**Seismic Walkdown Checklist (SWC)**

**Table C-2. Unit 0 Seismic Walkdown Checklists (SWCs)**

Peach Bottom Atomic Power Station Unit 2  
MPR-3815, Revision 3  
Correspondence No. RS-12-173

Equipment ID: 0AG012

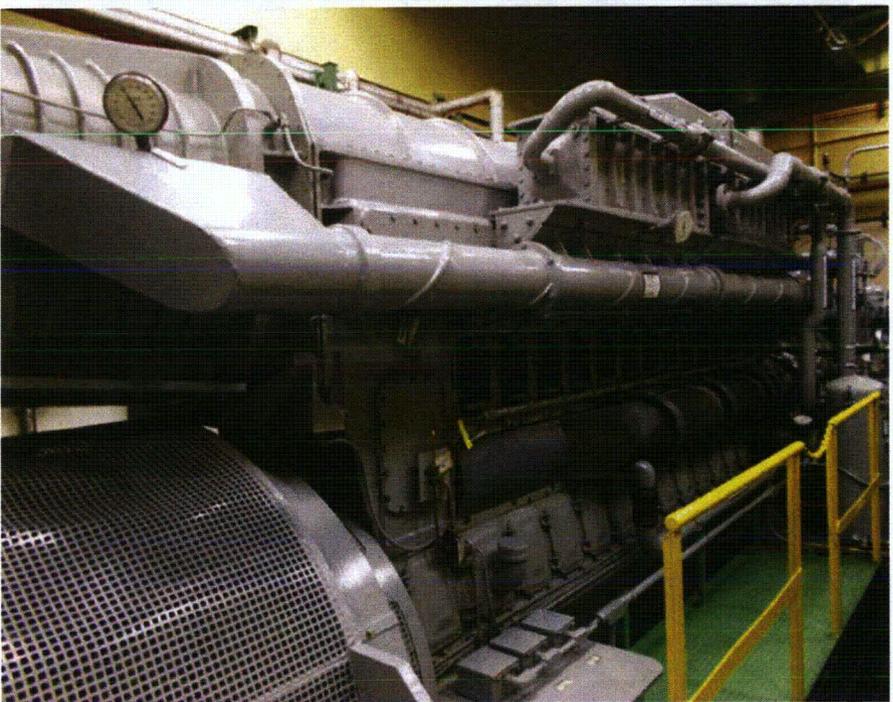
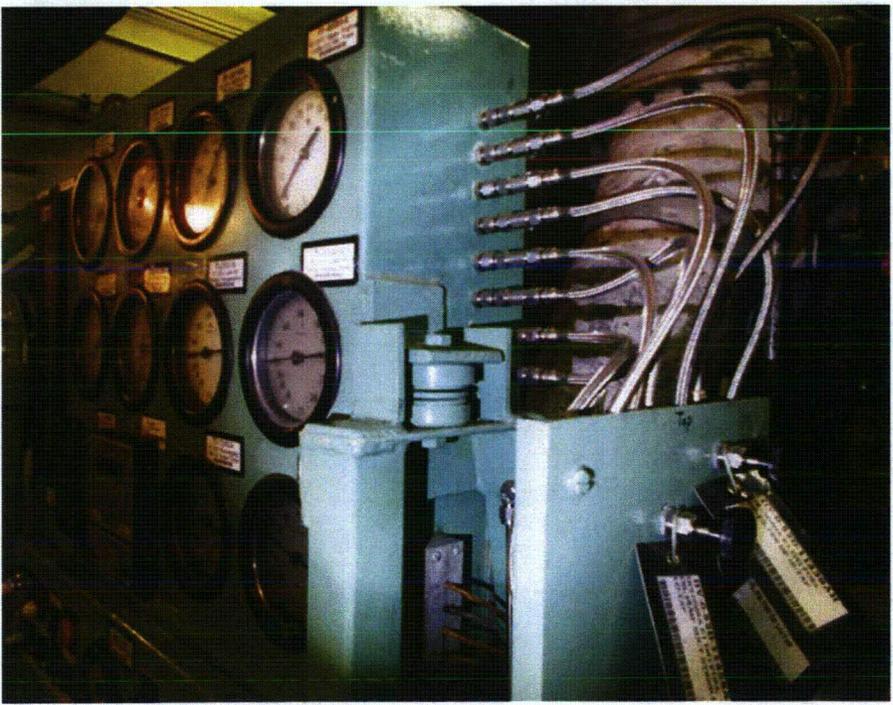
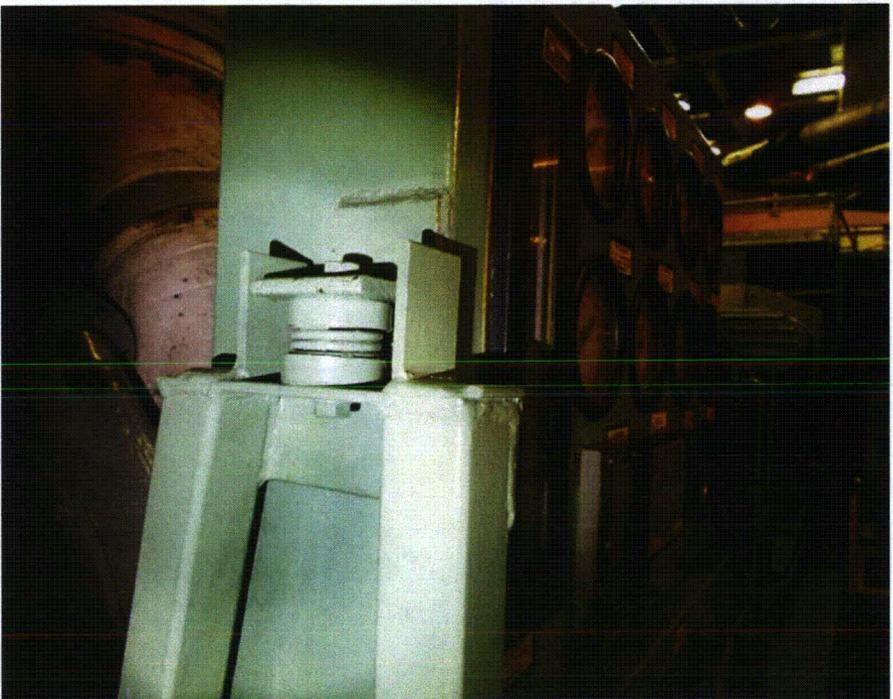
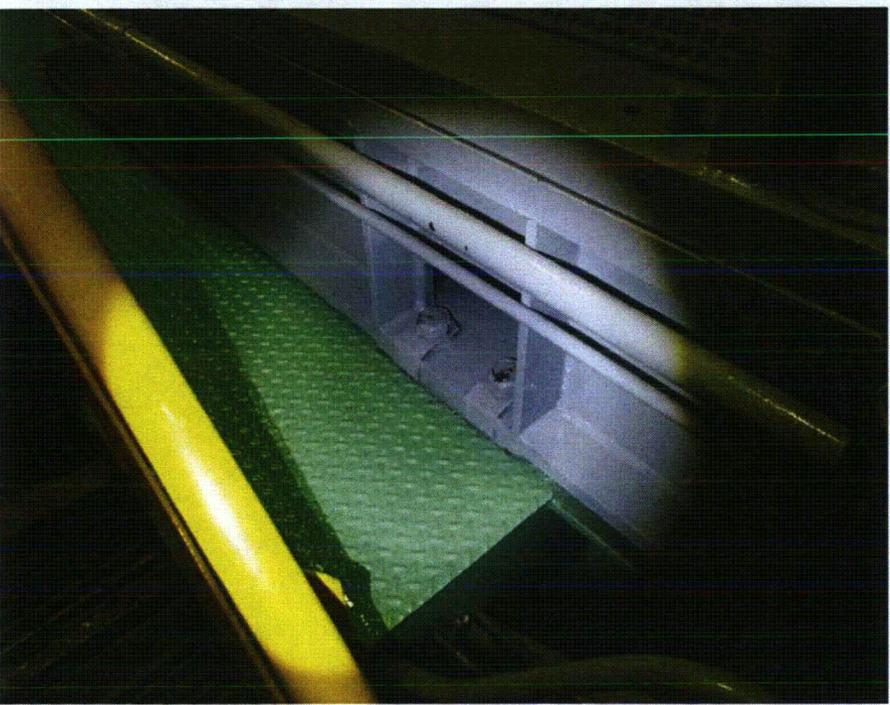
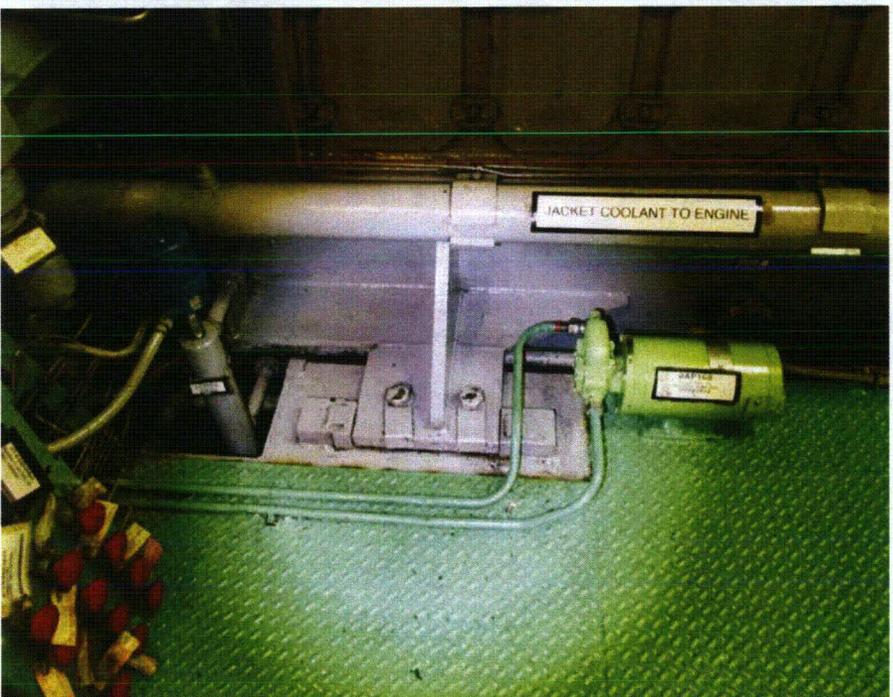
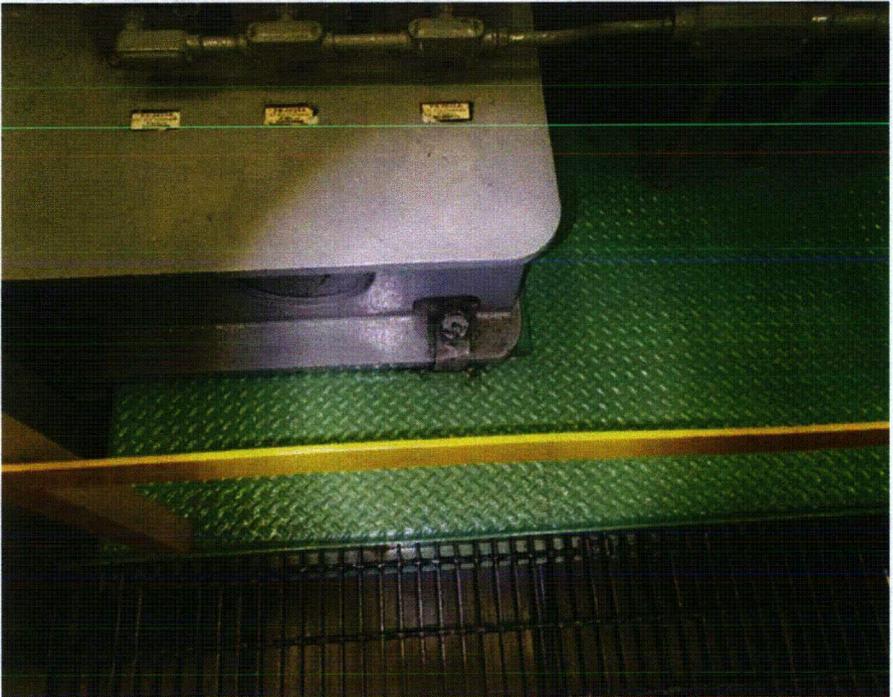
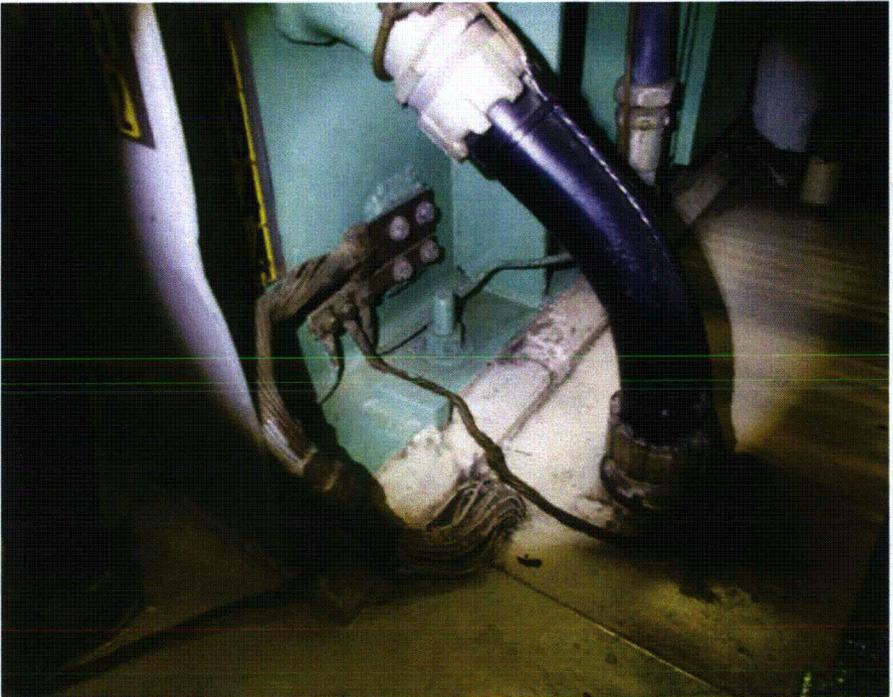
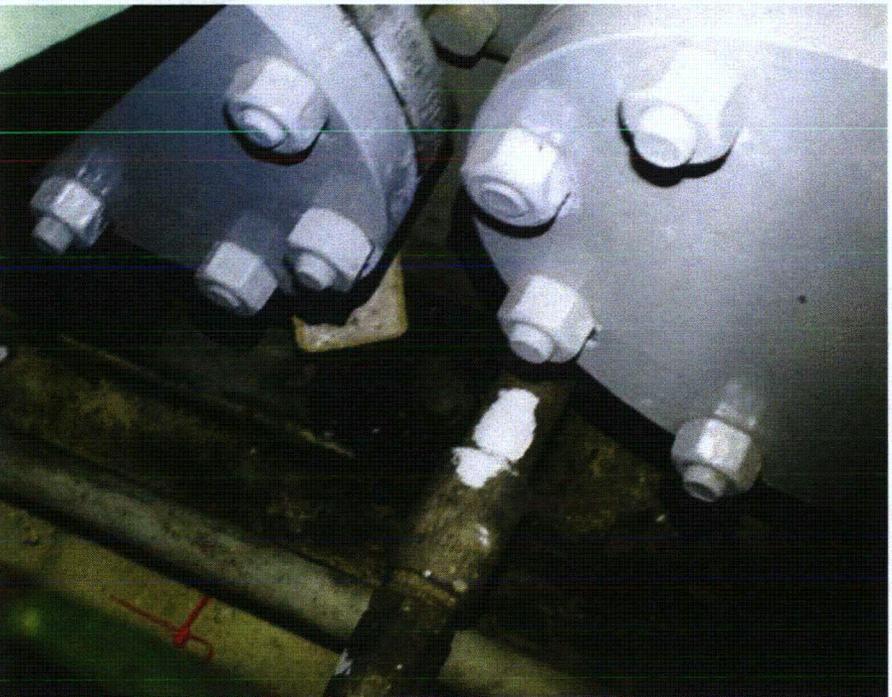
3. Is the anchorage free of corrosion that is more than mild surface oxidation?  Y  N  U  N/A  
*Mild surface oxidation noticed on support beam at north east corner of diesel.*

6. Based on the above anchorage evaluations, is the anchorage free of potentially adverse seismic conditions?  Y  N  U  
*Calc ES-155-1 (Rev 1) indicates 1 1/4" anchor bolts. Actual anchor bolts are 1" Anchor bolt size discrepancy documented in IR# 01438055. BMF 11/9/12*

*IPEEE - Crane controller securely mounted to the wall.  
 Seismic restraints have been added to the mounting of the diesel instrumentation panel next to the vibration isolators.*

Equipment ID: 0AV030

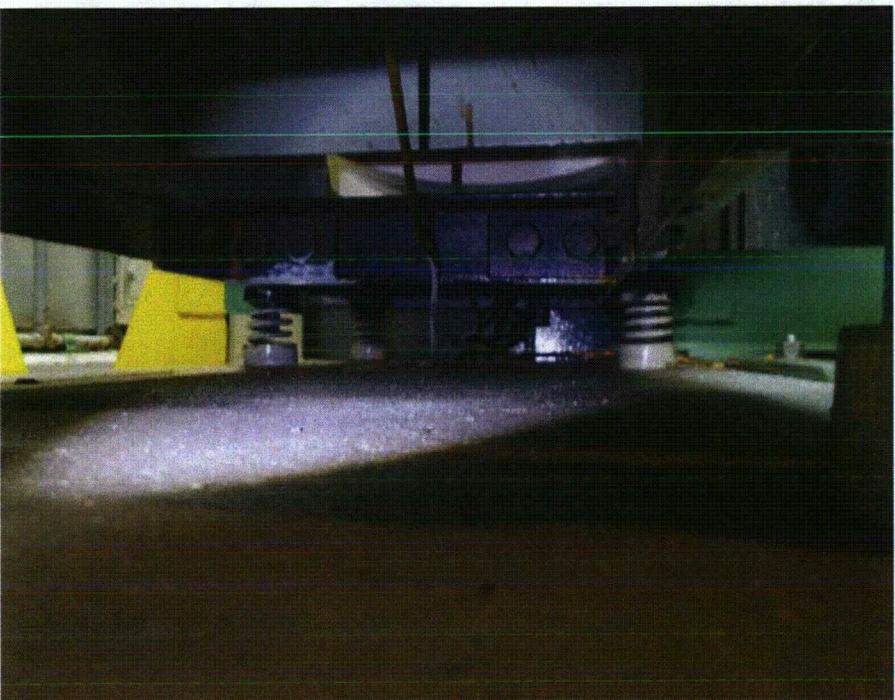
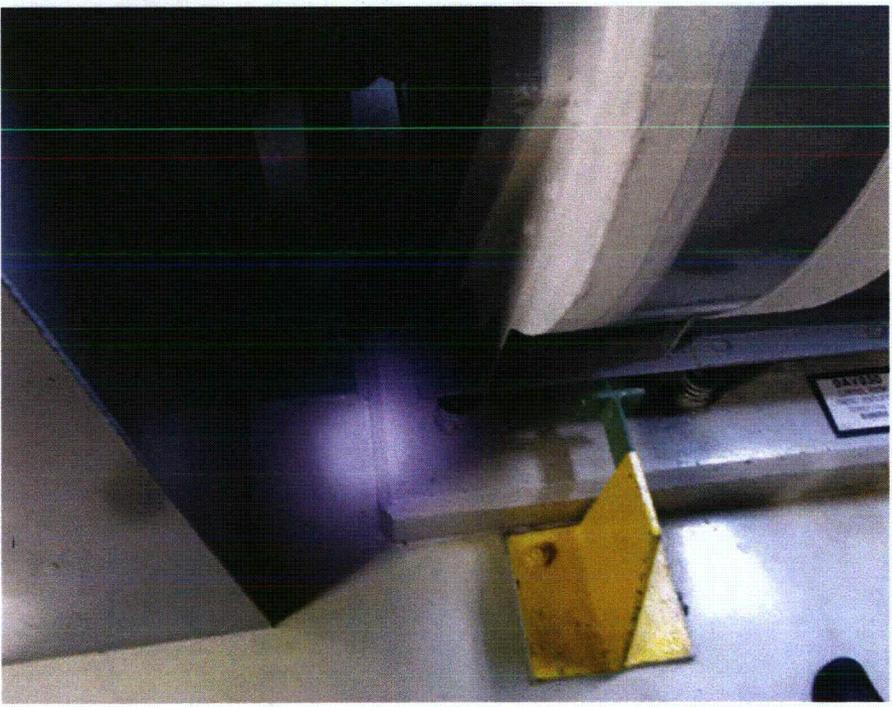
*East seismic log is slightly bent in vertical direction, has no impact on E-W load bearing capacity. Seismic support is still adequately engaged.*

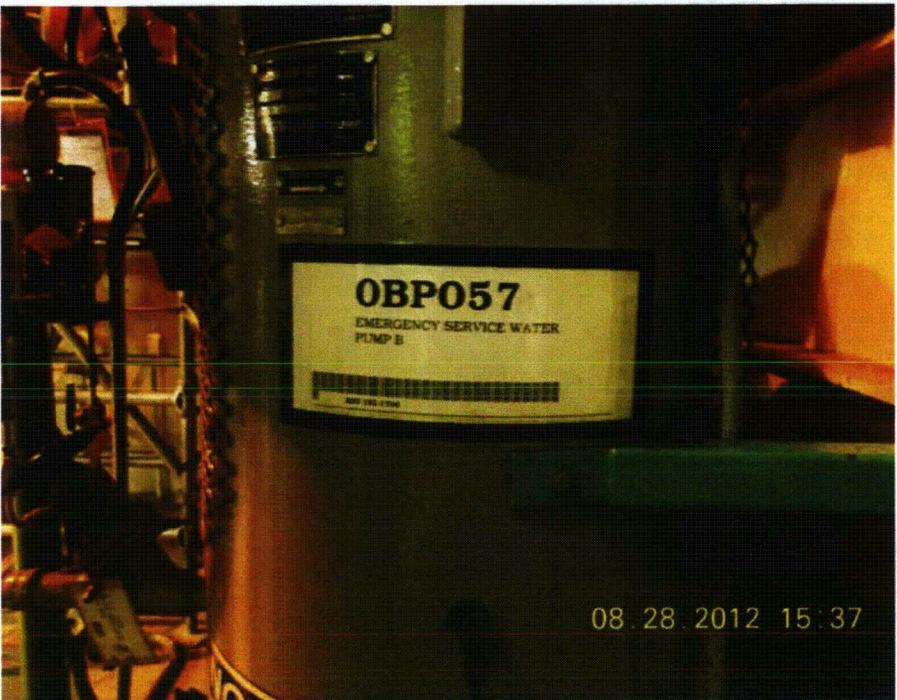
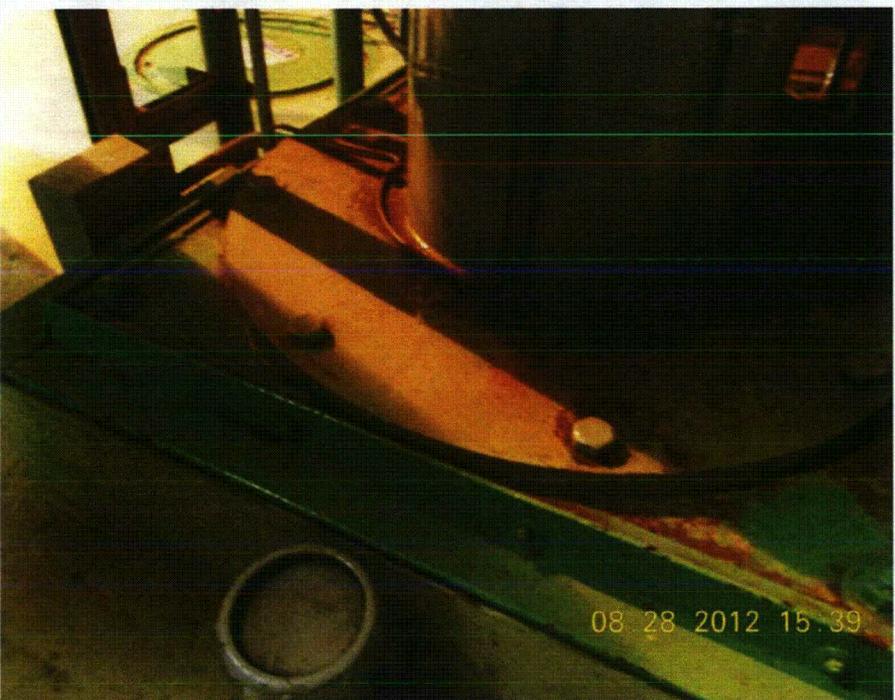
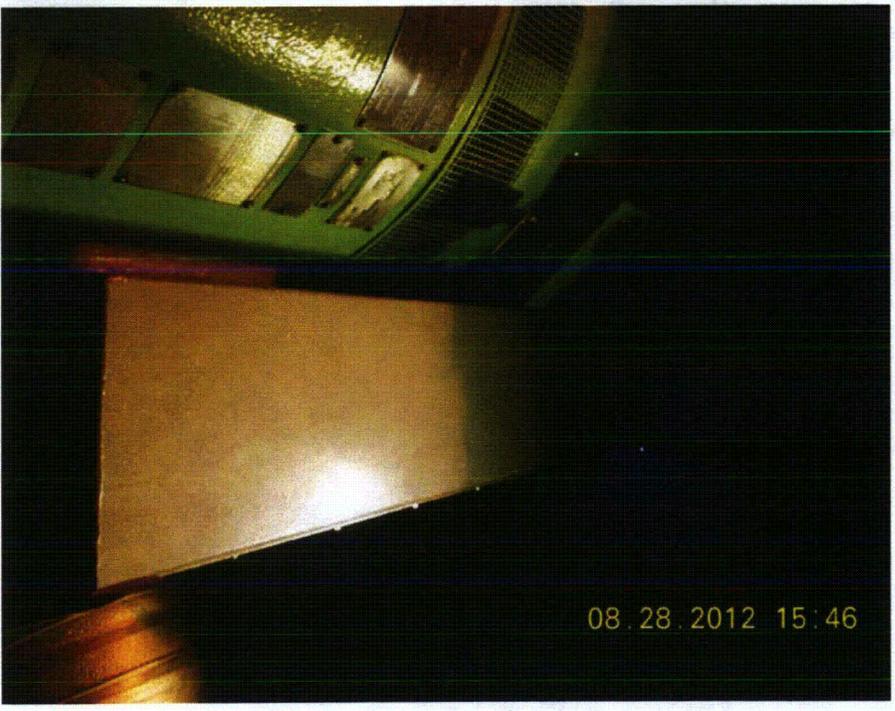
*Small clearance between pump junction box and overhead duct could result in lateral interference, but would not affect safety function of SSCs; interaction judged credible but not significant*
